# Access Compliance Report

## Public Rights-of-Way

Intersection ID: 10019134	Main Street: STROUD_PARK_CT	Cross Street: N/A	Location: S
ADA ID: 9DC2299CE167	Ramp Type: Perp	Initial Pass/Fail: Fail	Overall Compliance: No
		Severity Score: 10

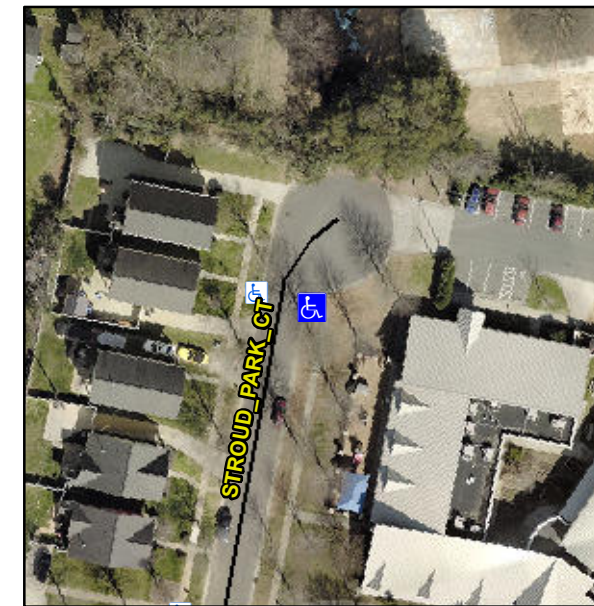
**Not Found, R304.5.1, R304.5.3**

Compliance	Description	Data	Compliance	Description	Data
N/A	Ramp Length (in)	44.0	Yes	Ramp Slope (%)	6.2
No	Ramp Width (in)	47.5	No	Ramp XSlope (%)	4.2
N/A	Flare Type LT	N/A	N/A	Flare Type RT	N/A
N/A	Flare Slope LT (%)	N/A	N/A	Flare Slope RT (%)	N/A
N/A	Flare Traversable LT?	N/A	N/A	Flare Traversable RT?	N/A
N/A	Landing Length (in)	N/A	N/A	DWS Provided?	N/A
N/A	Landing Width (in)	N/A	N/A	DWS Contrast?	N/A
N/A	Landing Slope (%)	N/A	N/A	DWS Length (in)	N/A
N/A	Landing X Slope (%)	N/A	N/A	DWS Full Width?	N/A
N/A	Landing Curb? (Y/N)	N/A	N/A	DWS Offset (in)	N/A
N/A	Shared Landing?	N/A			
N/A	Gutter Ponding?	N/A	N/A	Gutter Slope (%)	N/A
N/A	Gutter Lip Ht (in)	0.5	N/A	Gutter X Slope (%)	N/A
N/A	Painted X Walk1?	No	N/A	Painted X Walk2?	N/A
	X Walk 1 Direction	To SW		X Walk 2 Direction	N/A
N/A	X Walk 1 Width (in)	N/A	N/A	X Walk 2 Width (in)	N/A
	X Walk 1 Slope (%)	0.4		X Walk 2 Slope (%)	N/A
	X Walk 1 X Slope (%)	3.6		X Walk 2 X Slope (%)	N/A

**Remove & Replace Entire Ramp.**
